# UNITED STATES PATENT AND TRADEMARK OFFICE

APPLICATION NO.	FILING DATE	FIRST NAMED INVENTOR	ATTORNEY DOCKET NO.	CONFIRMATION NO.
10/672,922	09/26/2003	Alex Ezra Cable	9314.0027	9462

**Office Action Summary**

FIG. 1

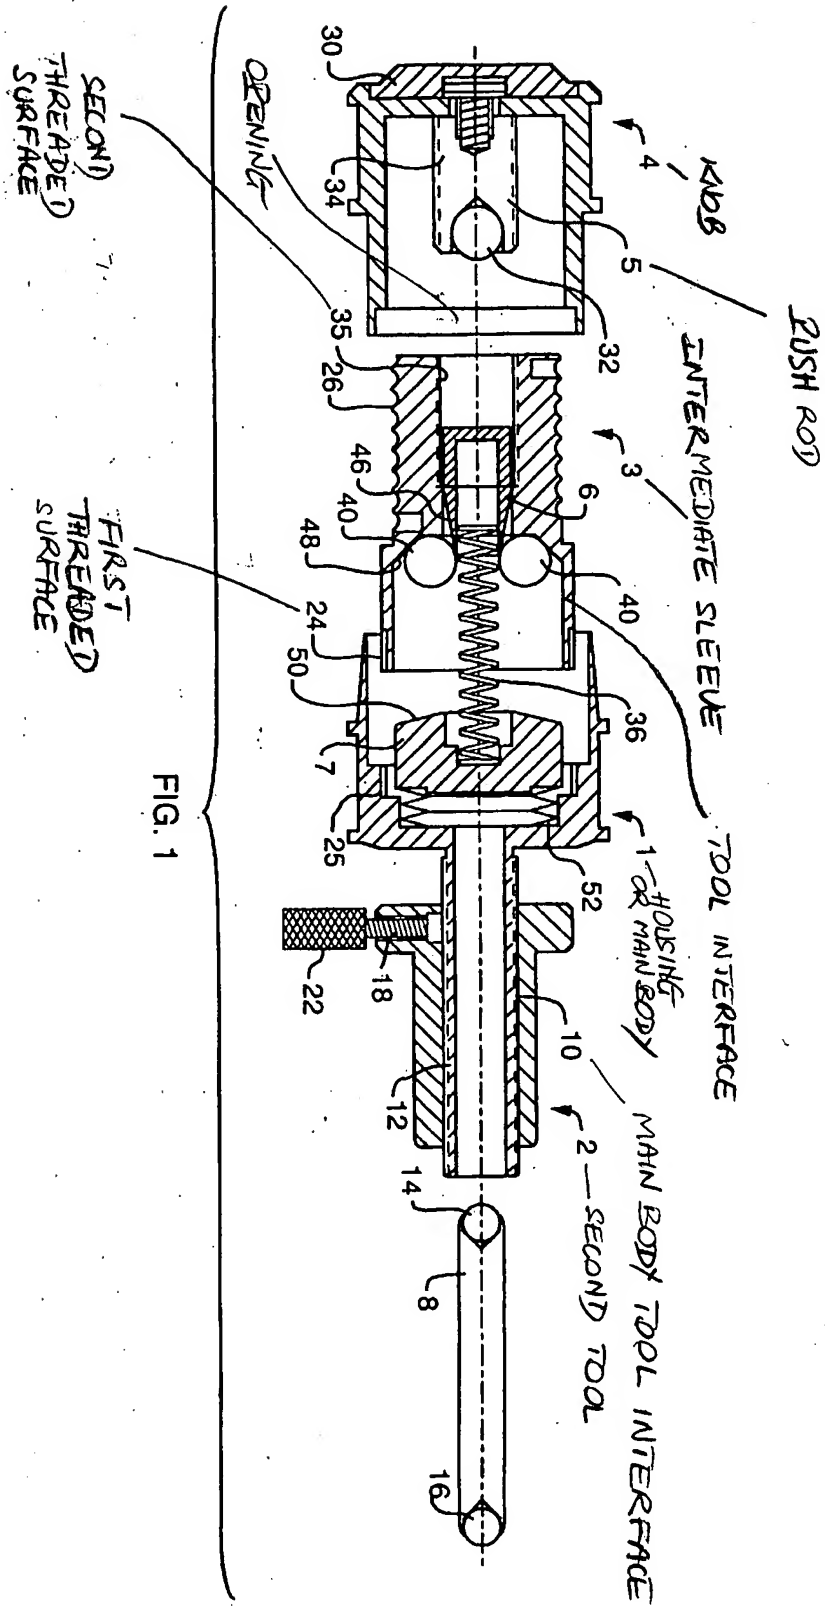
Regarding Claim 1, Cable teaches a differential adjuster, comprising: an intermediate actuator sleeve 3 with a first threaded surface 24, a second threaded surface 35, and a tool interface (at 48 in FIG. 1, see Attachment hereinafter "Att.").

Regarding Claim 5, the first threaded surface 24 is an external threaded surface and the second threaded surface 35 is an internal threaded surface. See FIG. 1.

Regarding Claim 41, the intermediate actuator sleeve 3 includes a tool interface (at 48 in FIG. 1, see Att.).

FIG. 2

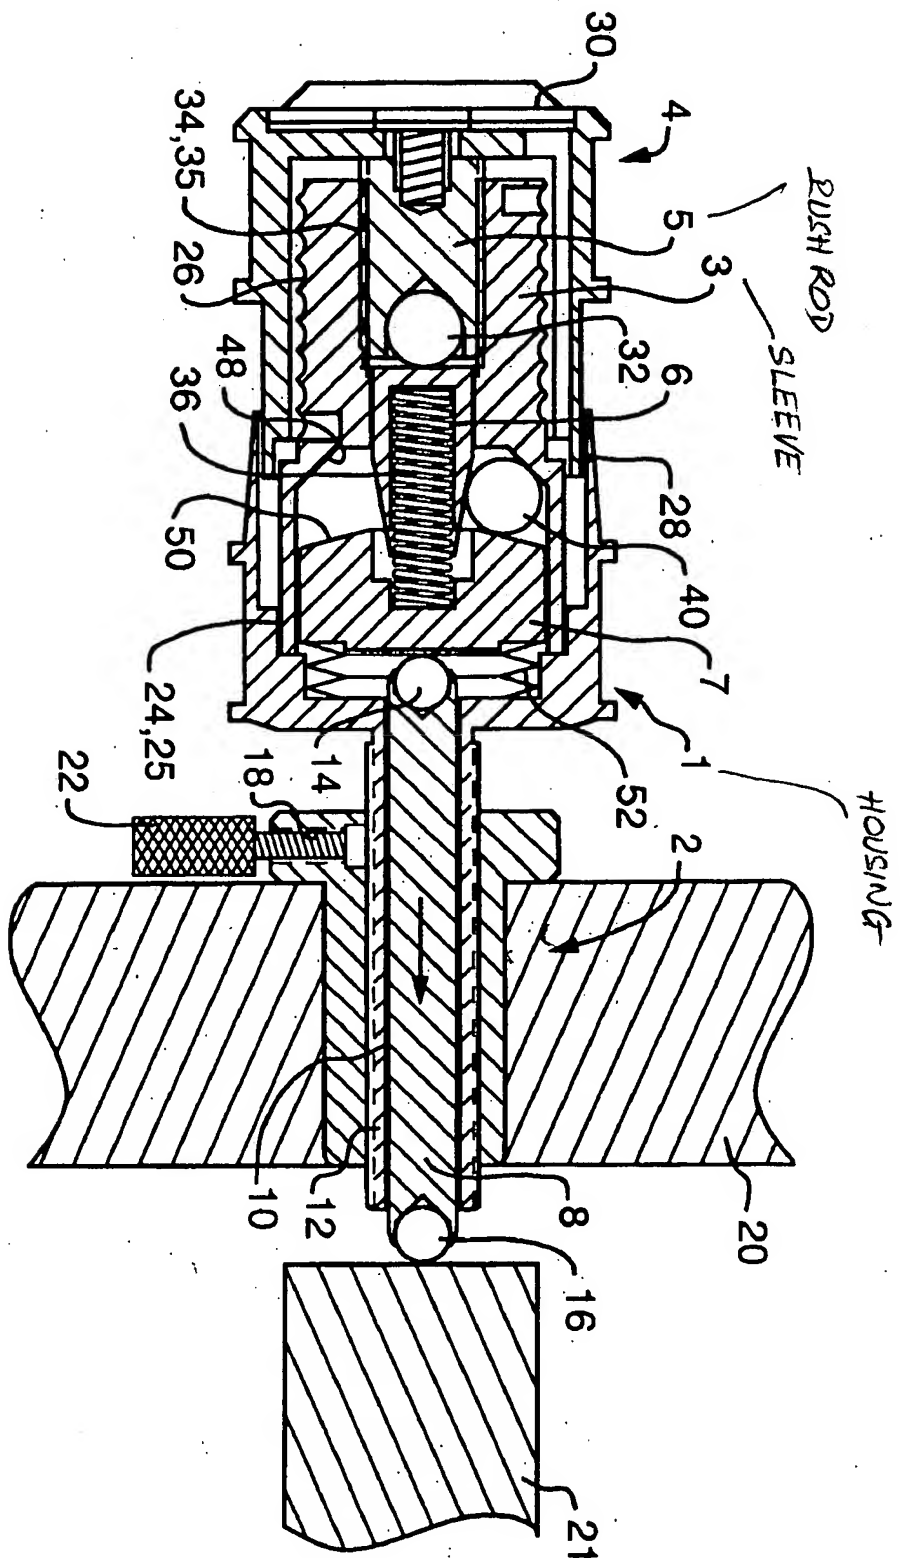
Regarding Claim 2, Cable teaches a rotationally constrained push rod 5 that engages the second threaded surface 35 (FIGS. 2 and 3), the push rod 5 moving at a rate related to the difference in pitch between the first threaded surface 24 and the second threaded surface 35 when the intermediate actuator sleeve 3 is rotated relative to a housing 1 that engages the first threaded surface 25. Cable, col. 2, line 6+. Moreover, note that referring the differential adjuster to the merely inferentially included element or intended use element, such as, the tool that engages the tool interface of the intermediate actuator sleeve is not accorded patentable weight.

Regarding Claim 3, the housing 1 and the push rod 5 are arranged so that the push rod 5 is capable of being rotationally constrained with respect to the housing 1. See FIGS. 2 and 3.

Regarding Claim 7, Cable's first threaded surface 24 is equivalent to the internal threaded surface 25 (FIG. 2) and Cable's second threaded surface 35 is equivalent to the external threaded surface 26. See MPEP 2144.06 *supra*.

Regarding Claim 25, the housing 1 is a component mount or positioner that engages the first threaded surface 24 of the intermediate actuator sleeve 3 (FIGS. 2 and 3).
